Project	CMHA Meadows RAD Renovations	Addendum Number	2
Project Number	18076.04	Date	09/12/2025
To	All Bidders		
<i>This addendum contains changes to the requirements of the bidding Documents, Project Manual and Construction Drawings which have been issued to date. Such changes are to be incorporated into the Construction Documents and shall apply to the work in the same meaning and force as if they had been included in the original documents. Wherever this Addendum modifies a portion of a paragraph of the Project Manual or a portion of any Drawing, the remainder of the paragraph or Drawing shall remain in force.</i>			
General	Clarifications: <i>Bid Form: See attached revised bid form showing line item for permit fee included.</i> <i>Do the gas lines in the laundry room need to be removed? Is the furnace the only gas fed item within the unit?</i> Response: Gas lines are stubbed into the laundry area for future use of a gas appliance. No work is to be done on the gas lines in the laundry room as a part of this renovation. <i>How should the curb be addressed where the sidewalk on the accessible route widens?</i> Response: See Civil drawings updates as a part of this Addendum. <i>Do y

Sheet H201 – ENLARGED UNITS HVAC PLANS

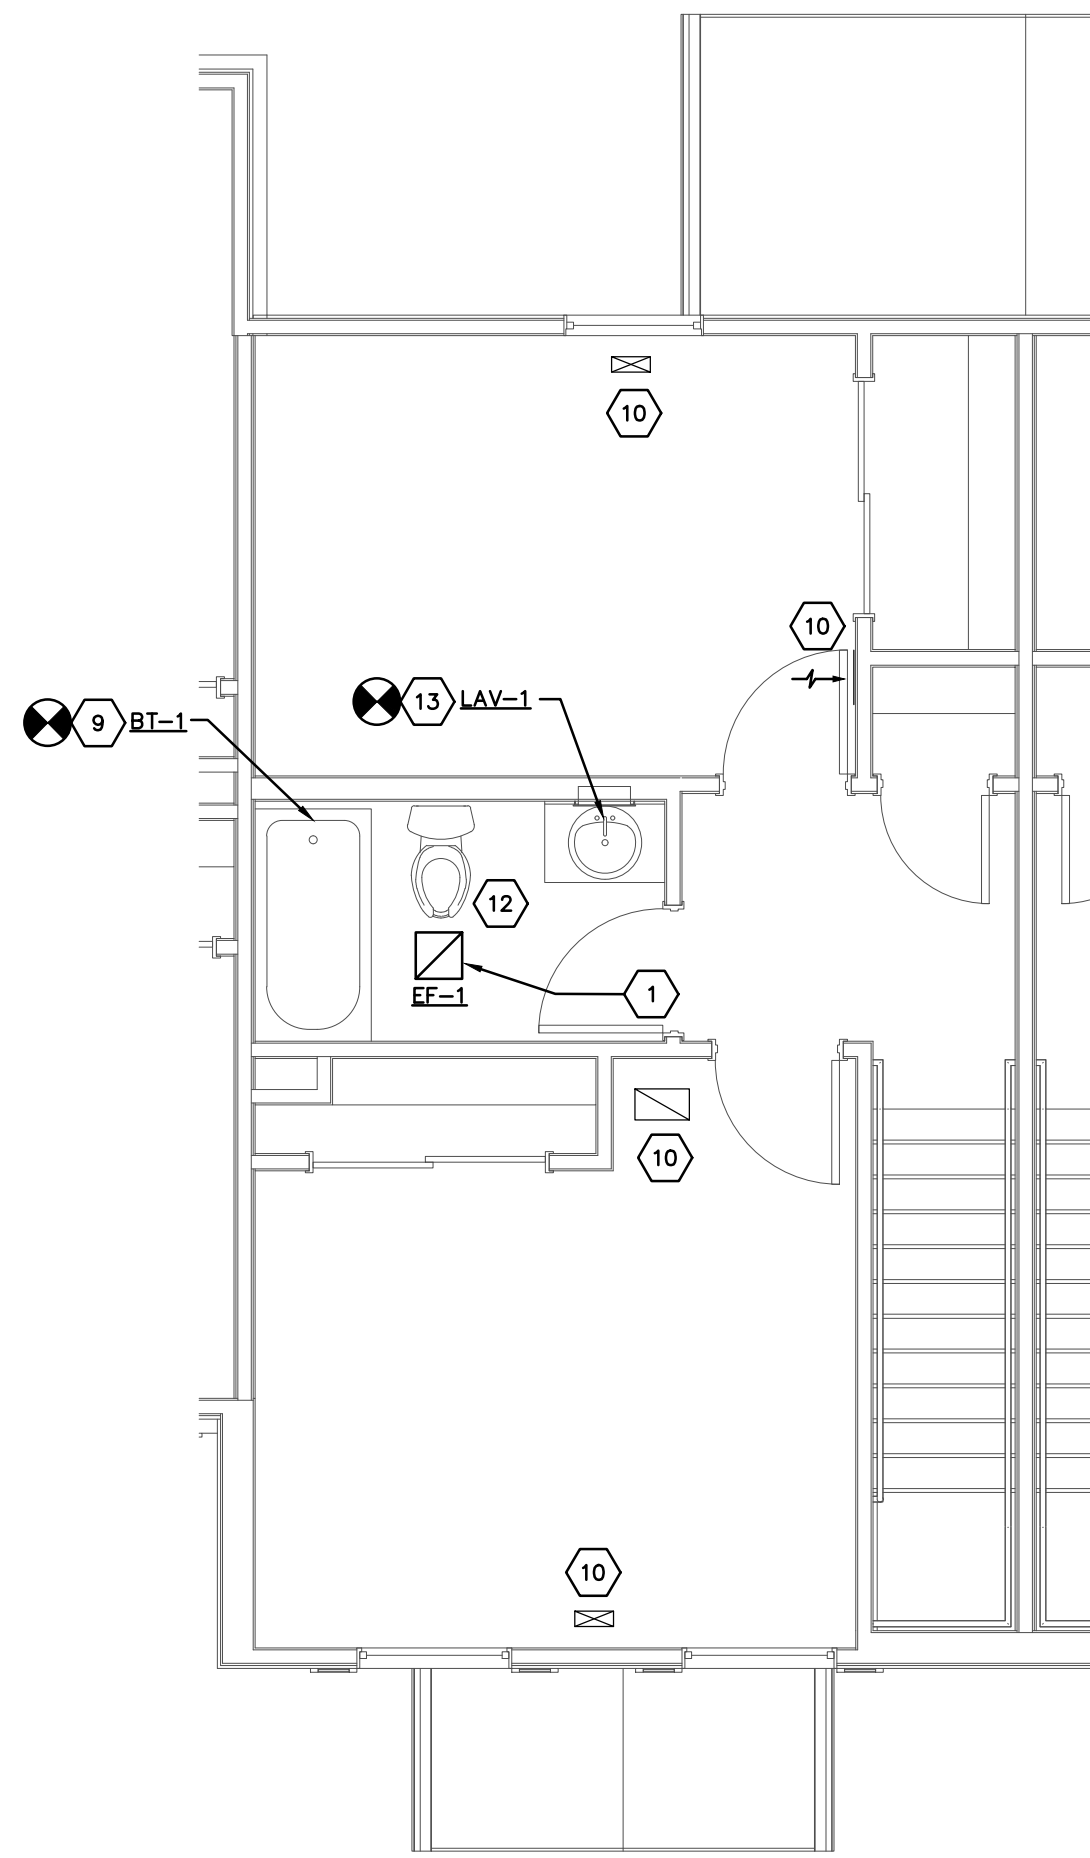
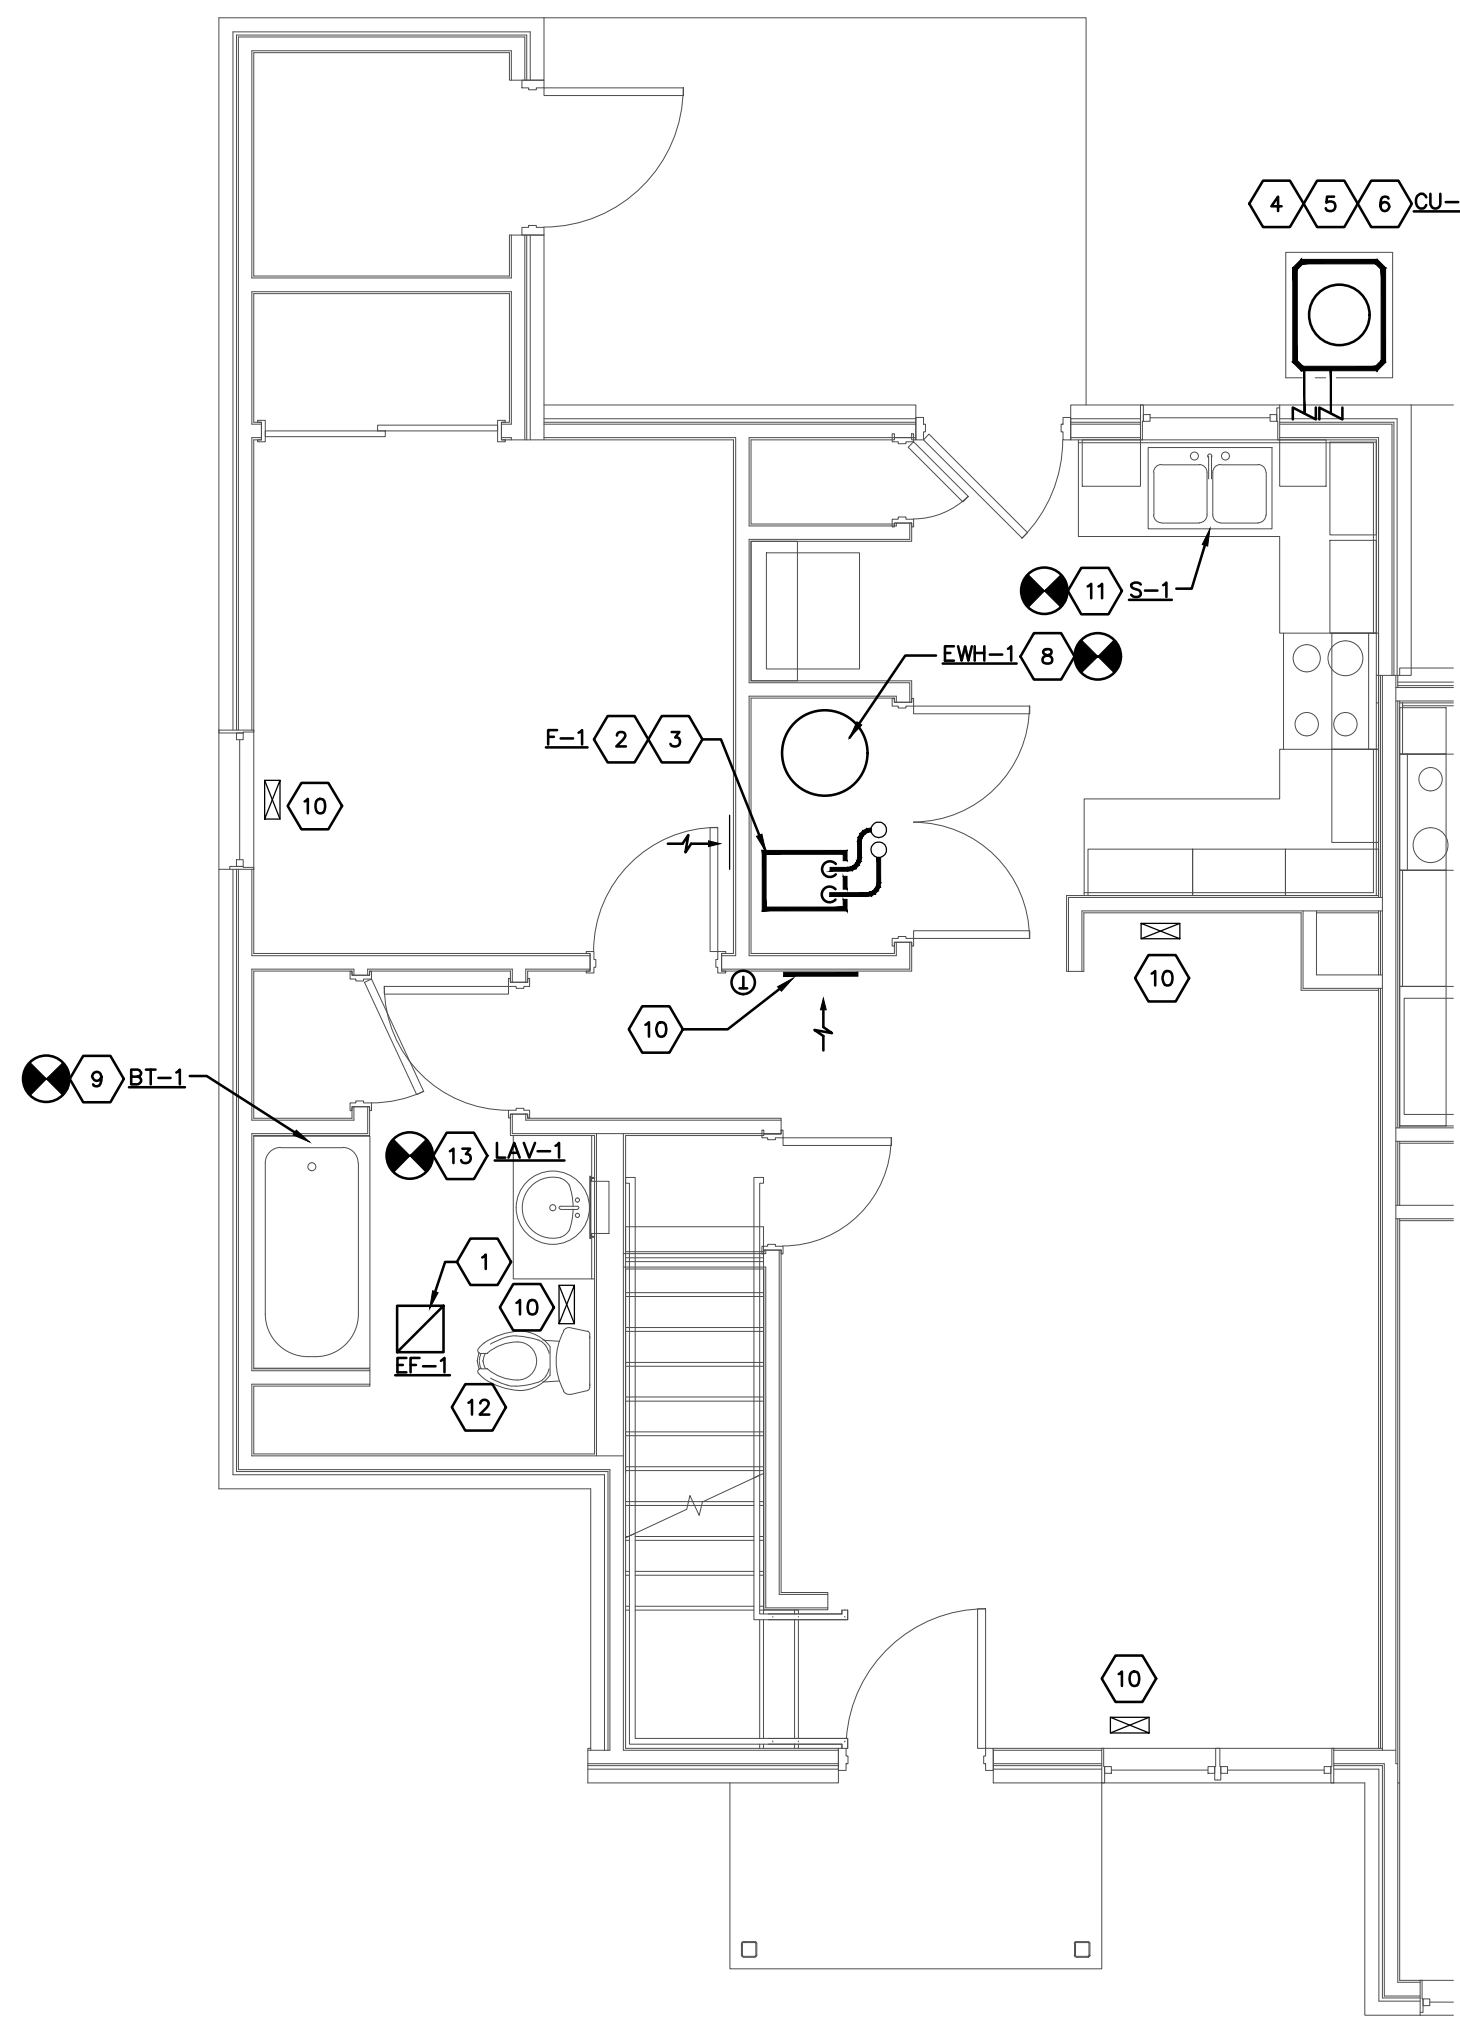
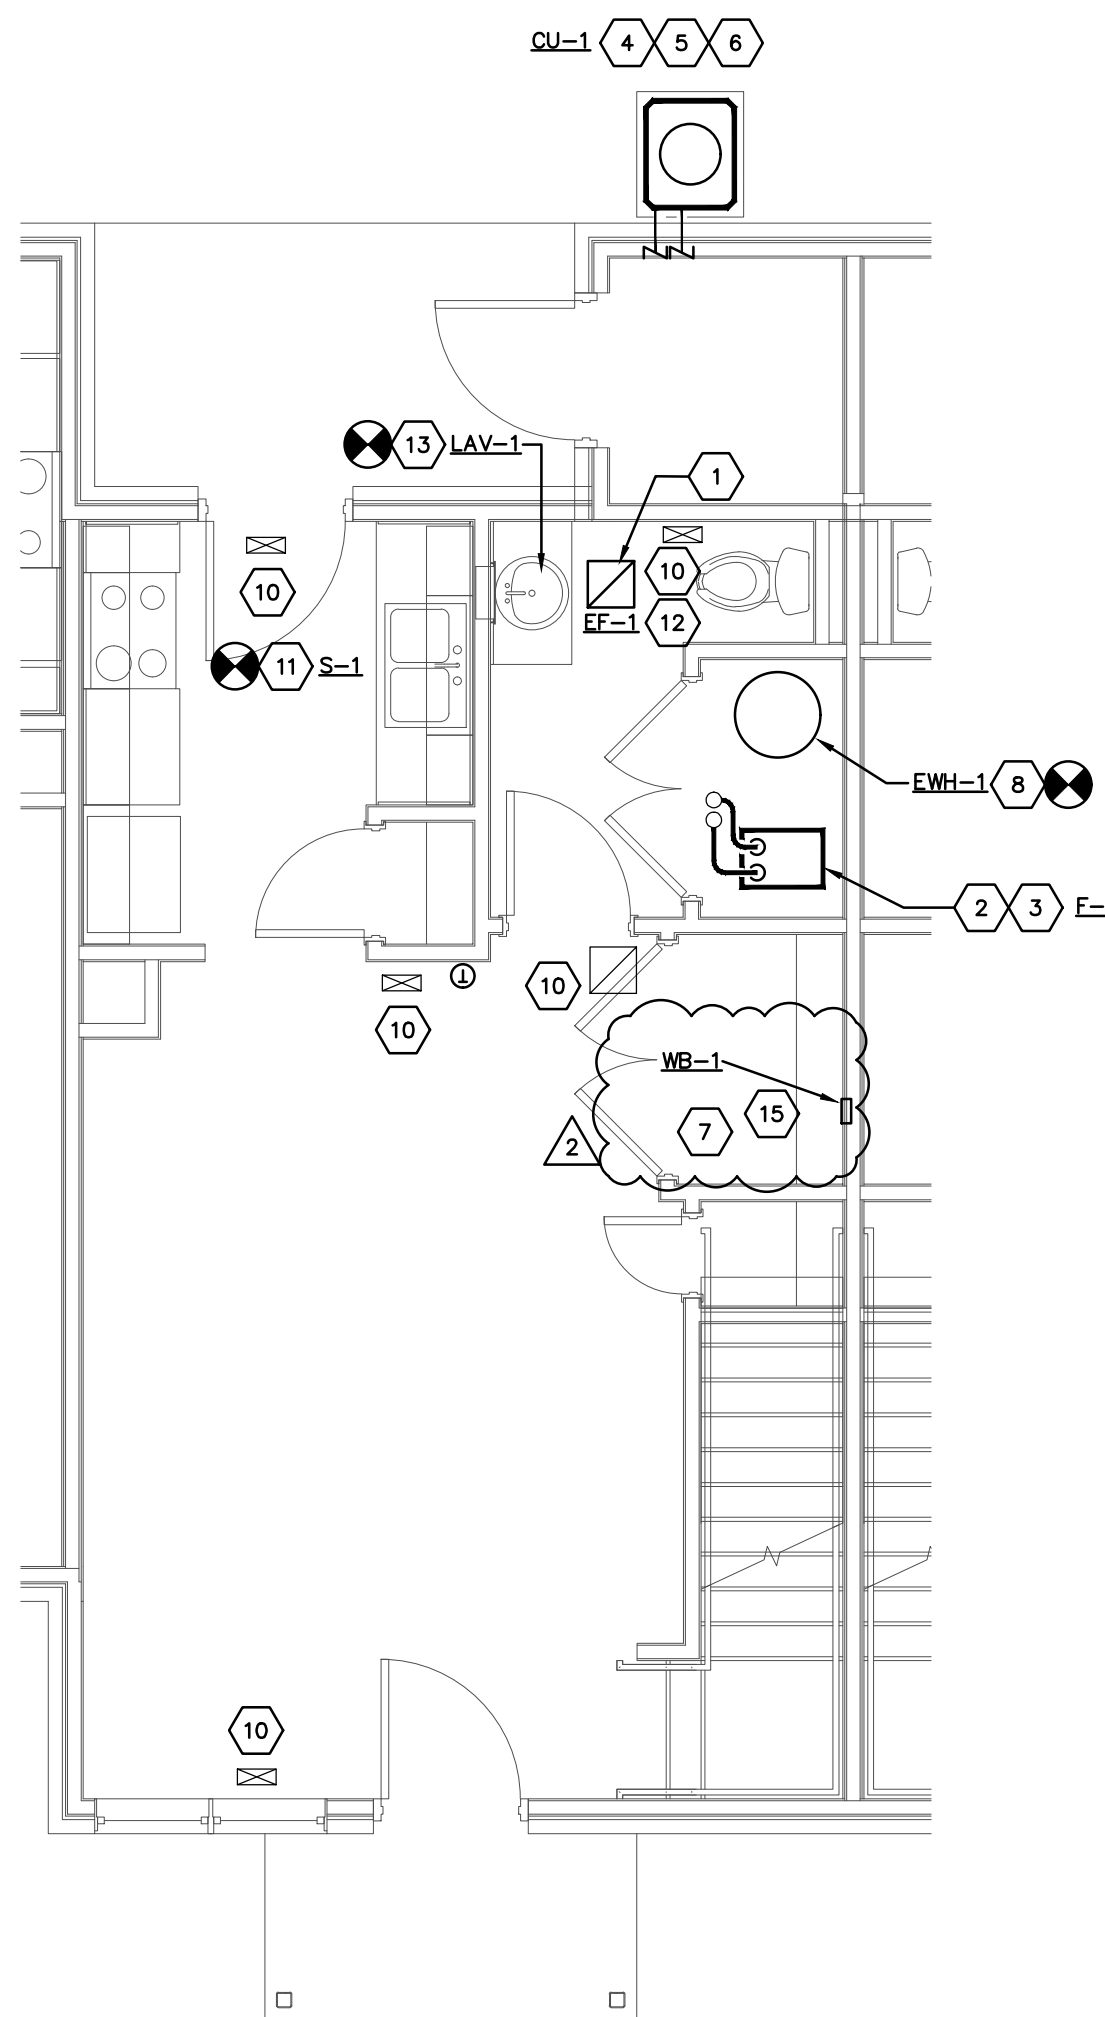
1. ADDED WB-1 washer box replacement in Unit 2-A first floor, Unit 2-B first floor, and Unit 3-A second floor.
2. ADDED Coded Note #15.

- REPLACE EXISTING WASHER BOX AT THIS LOCATION. FIELD VERIFY EXACT LOCATION. SEE "PLUMBING FIXTURE SCHEDULE" ON SHEET H900.
